VERMONT AGENCY OF TRANSPORTATION
PROPOSED IMPROVEMENT BRIDGE PROJECT
TOWN OF PUTNEY, COUNTY OF WINDHAM
US RT. 5 FAS (MAJOR COLLECTOR), BRIDGE 19A

EXPANSION ELASTOMERIC BEARING DETAIL

STRUCTURAL PRODUCTS CORP.
DOVER, NJ JOB # 3383

DWG NO: JAM10A3RA SHEET NO. 3 OF 3

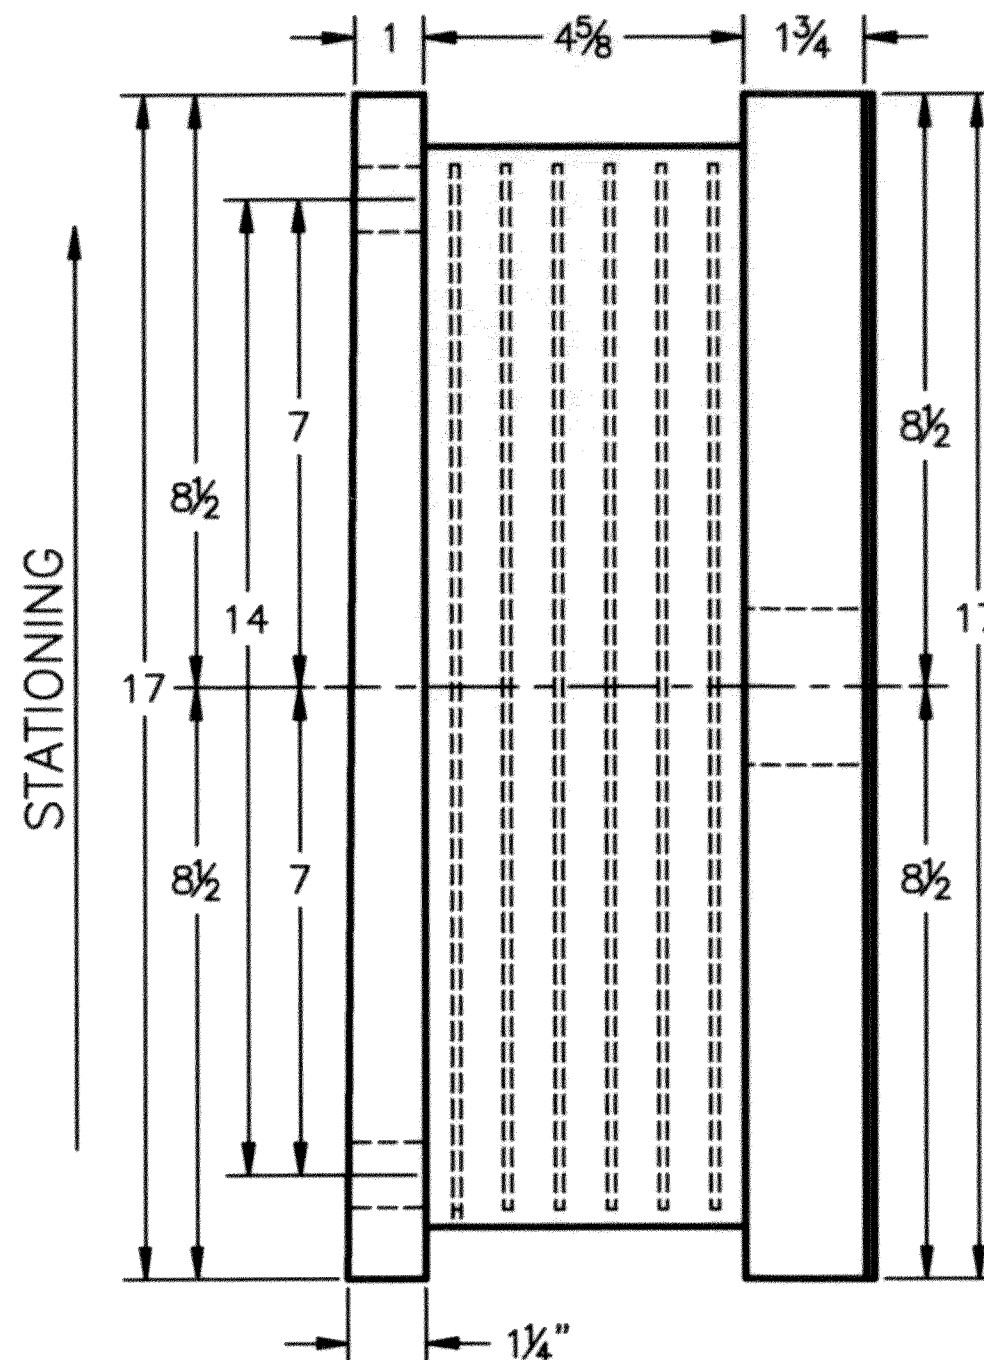
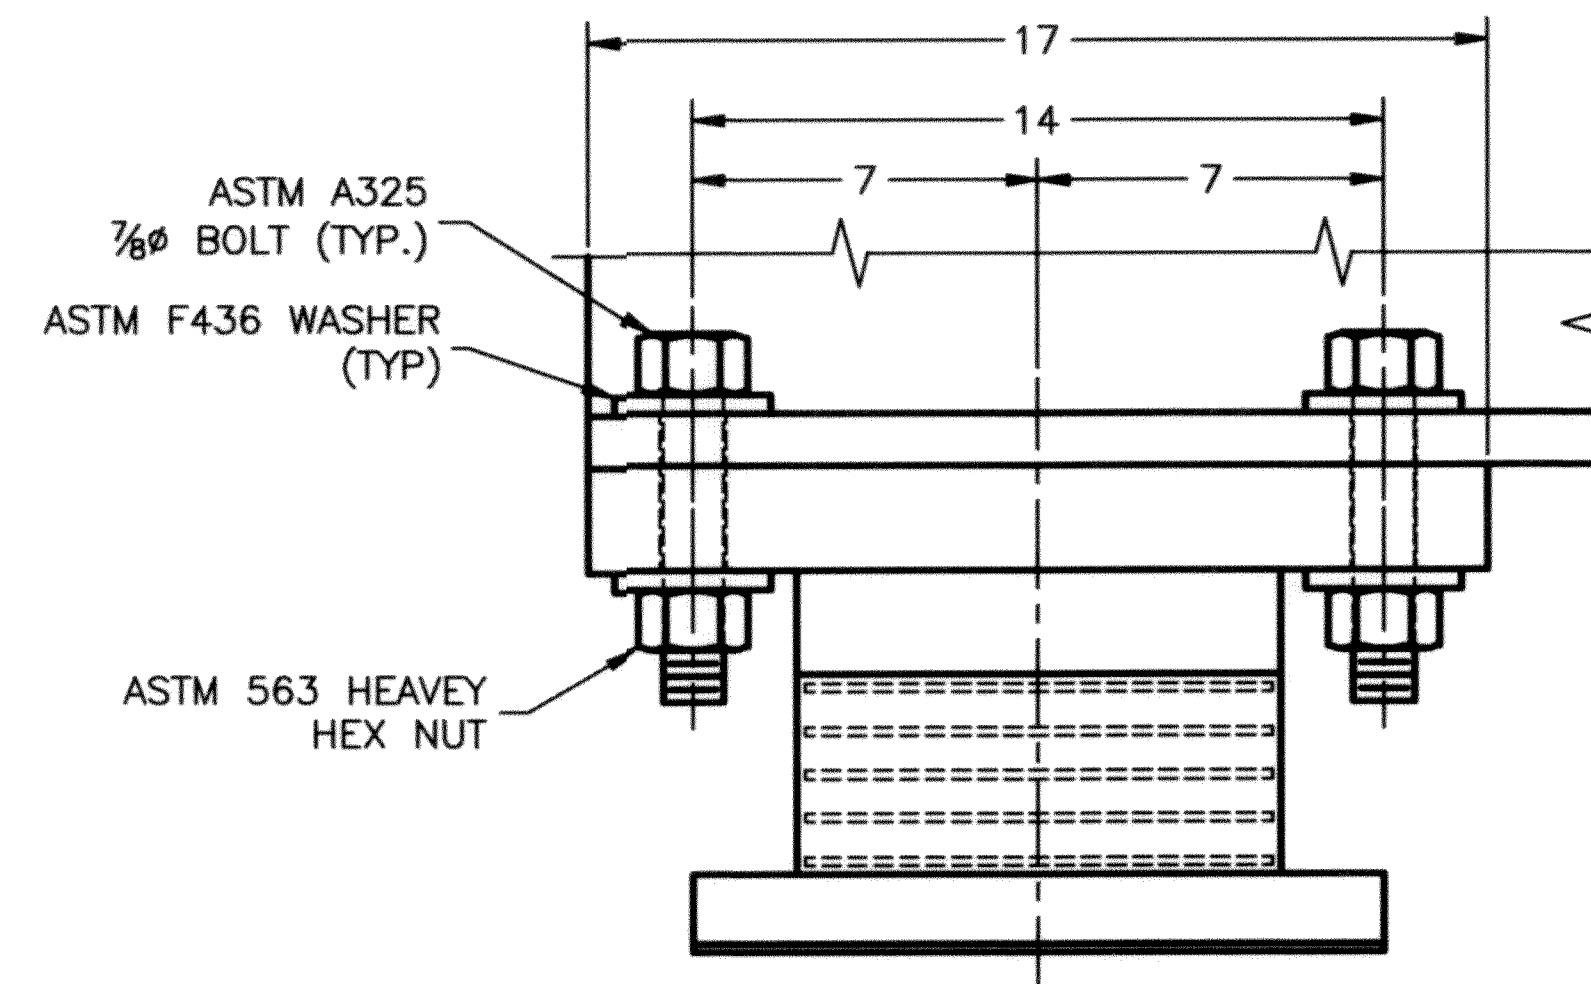
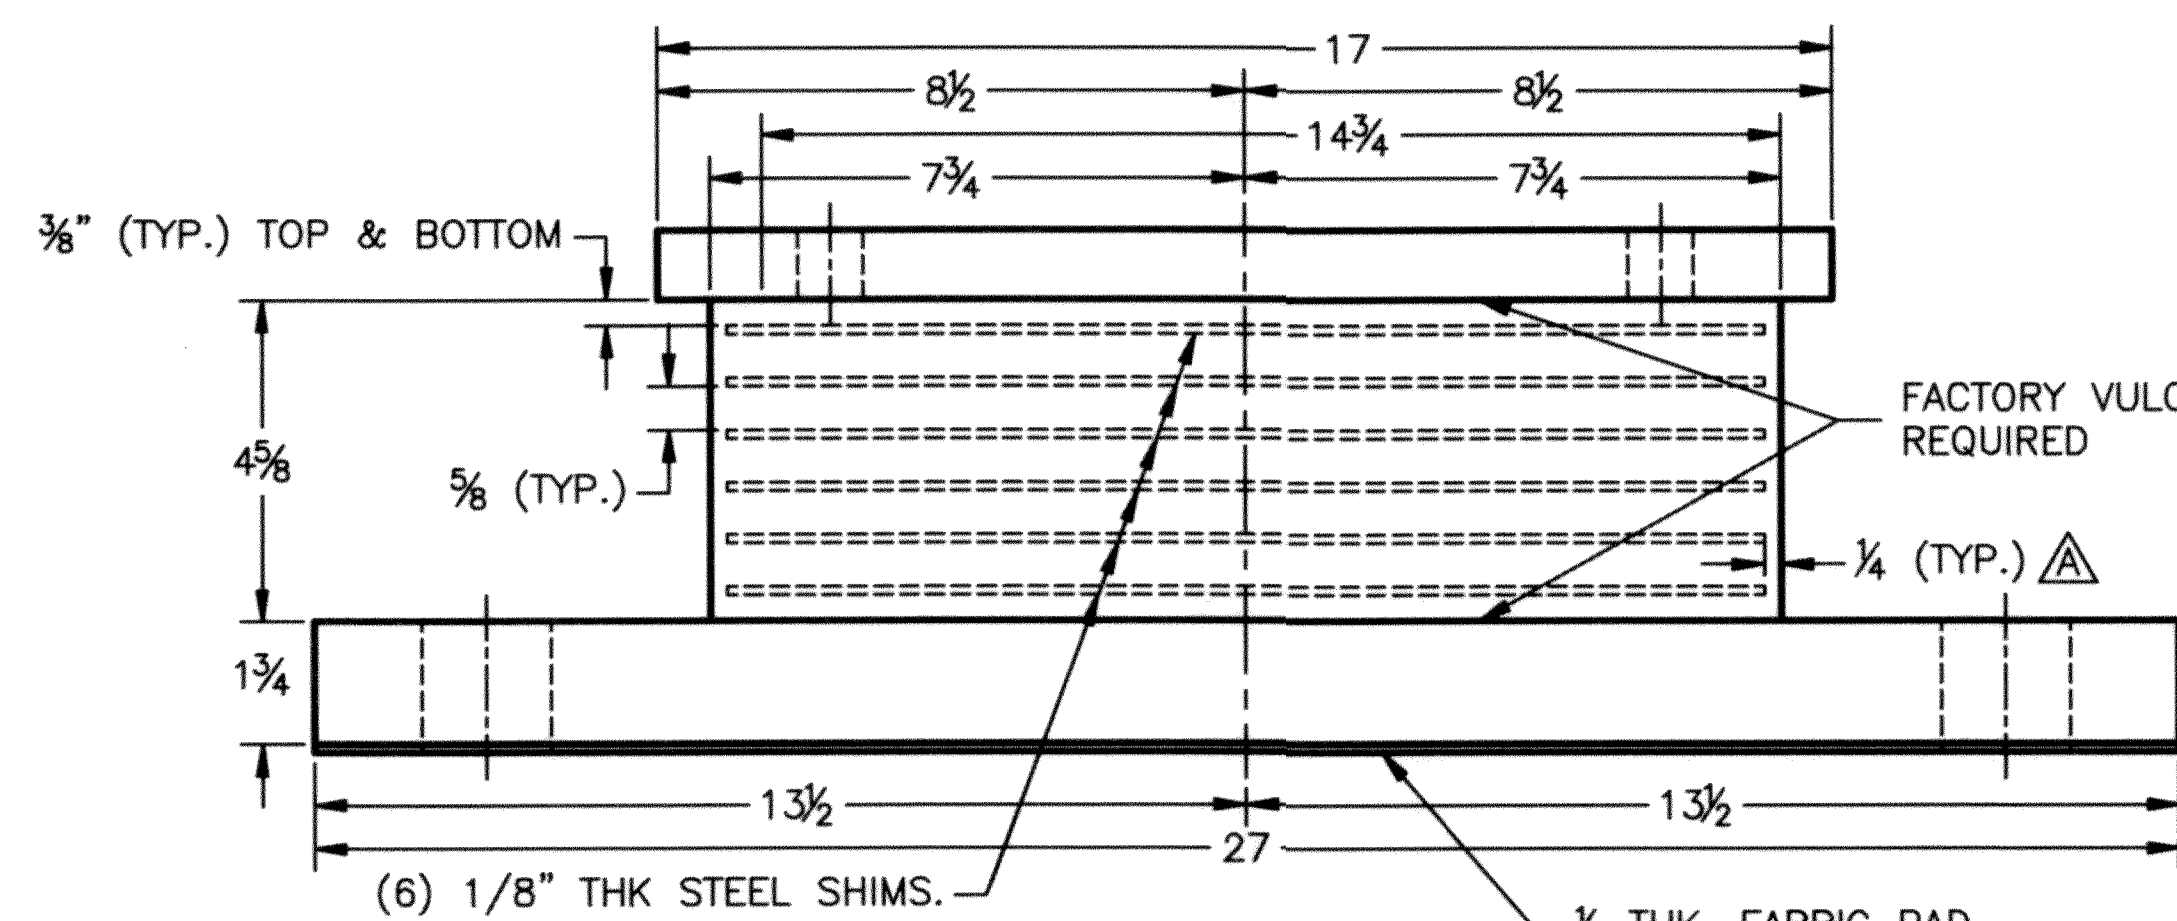
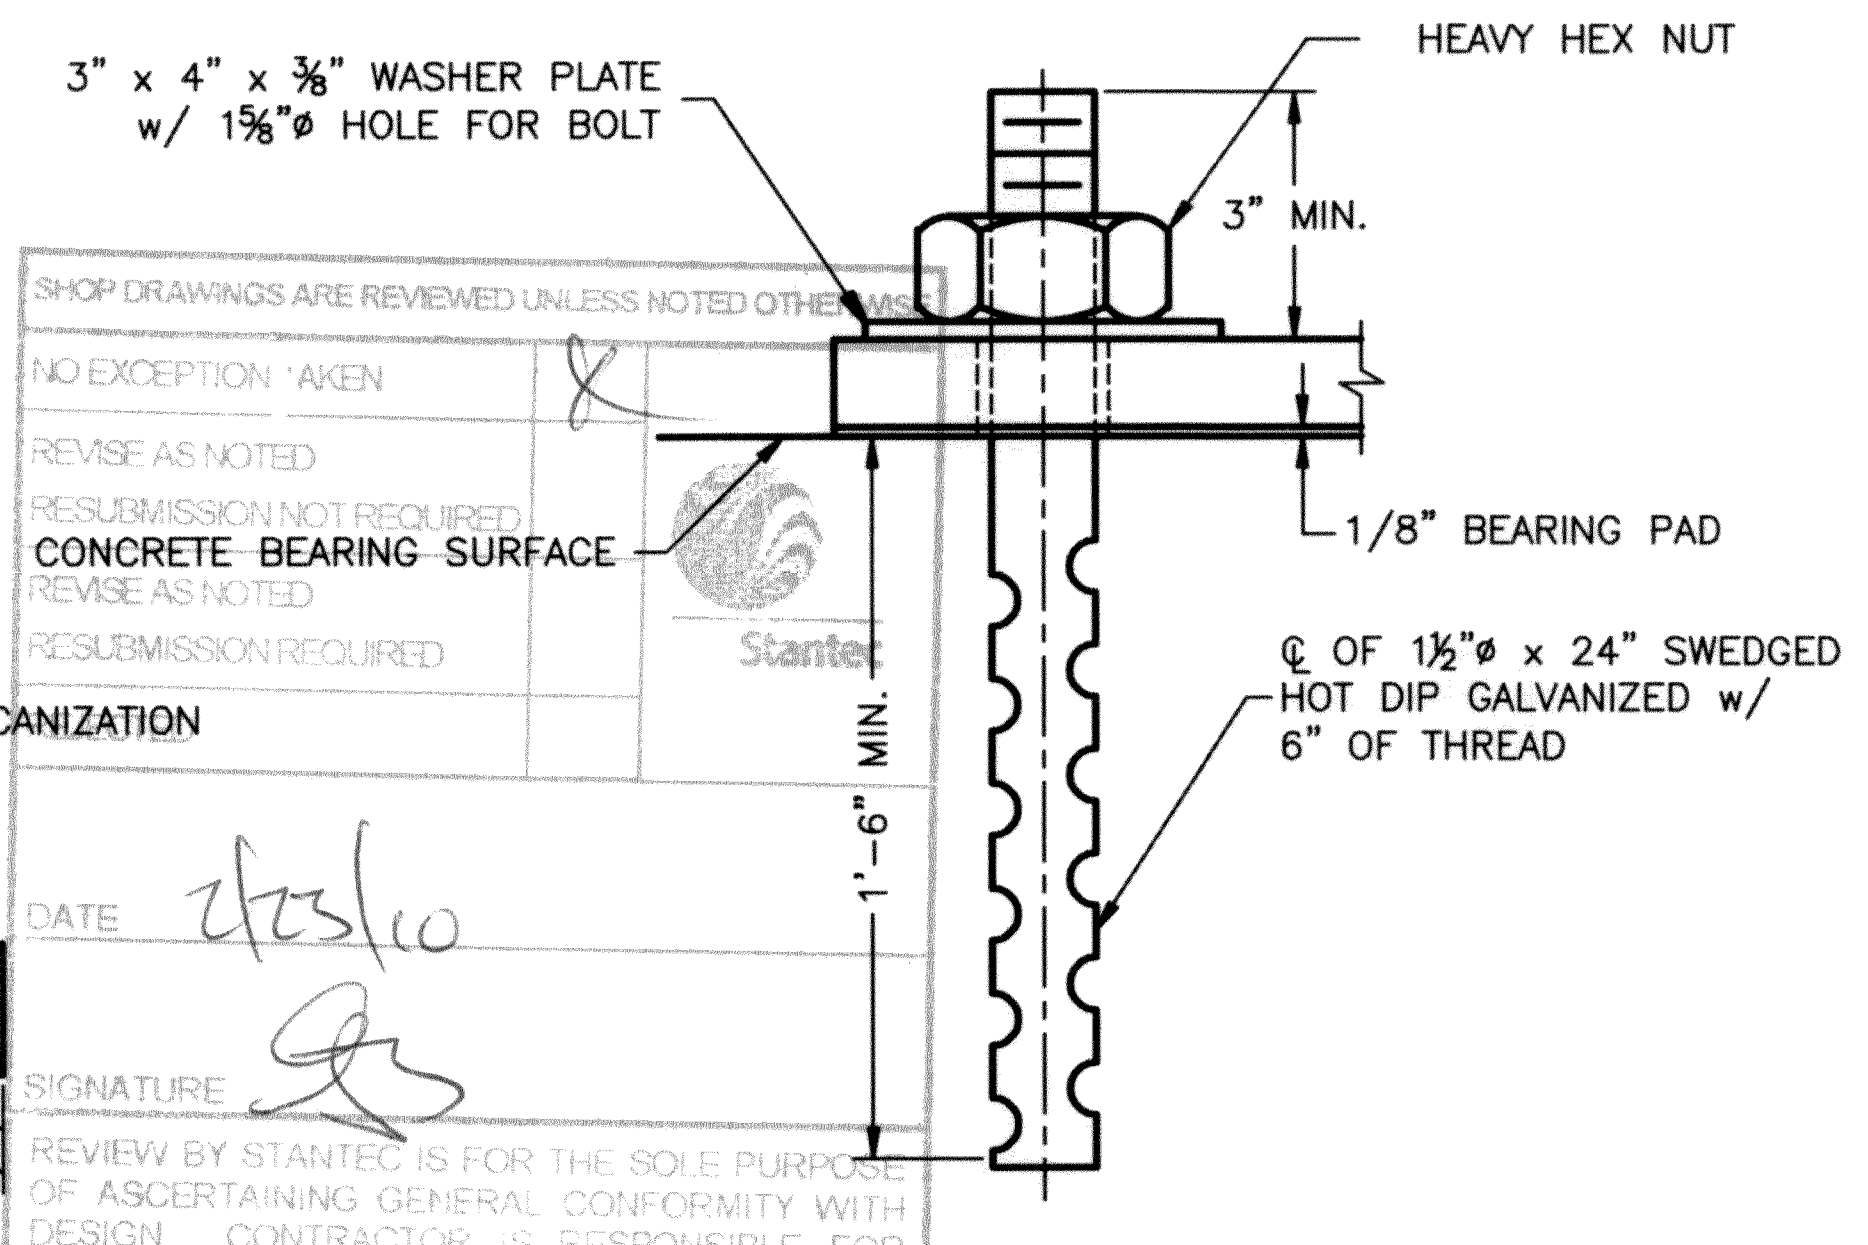
REVISIONS				
ZONE	REV	DESCRIPTION	DATE	APPROVED
--	A	PER ENGINEER'S MARK	2/23/10	C.A.M.
